NAVSHIPS 0967-191-7012
PERMANENT CHANGE NO. 1

TO
TECHNICAL MANUAL
FOR
RADIO TRANSMITTING SET AN/URT-23 (V)
(NAVSHIPS 0967-191-7010)

2.81 Page 5-42, figure 5-9: Add callouts as shown on following illustration.

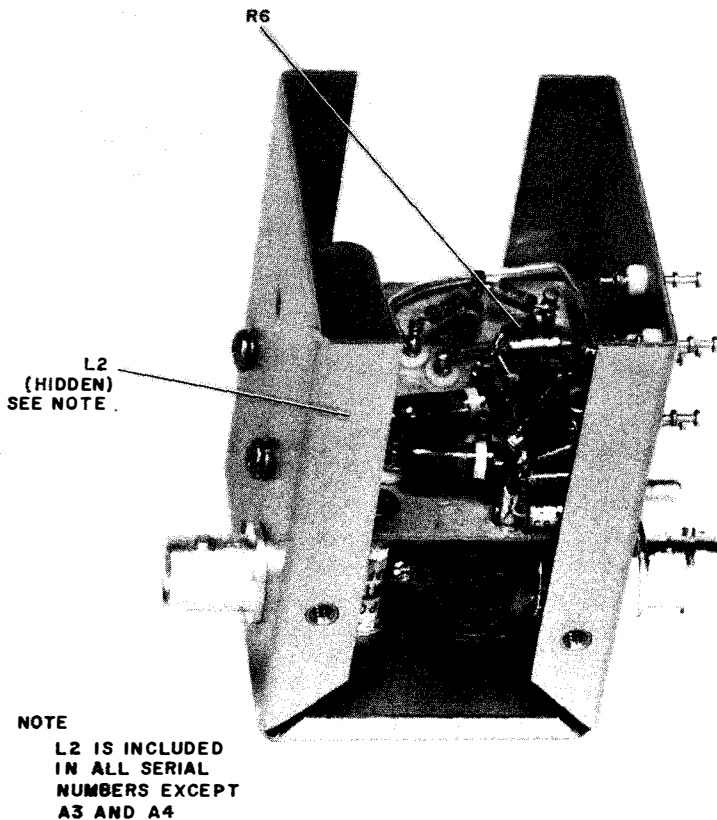
Add:

"NOTE 1: Not used in units with serial numbers greater than A170."
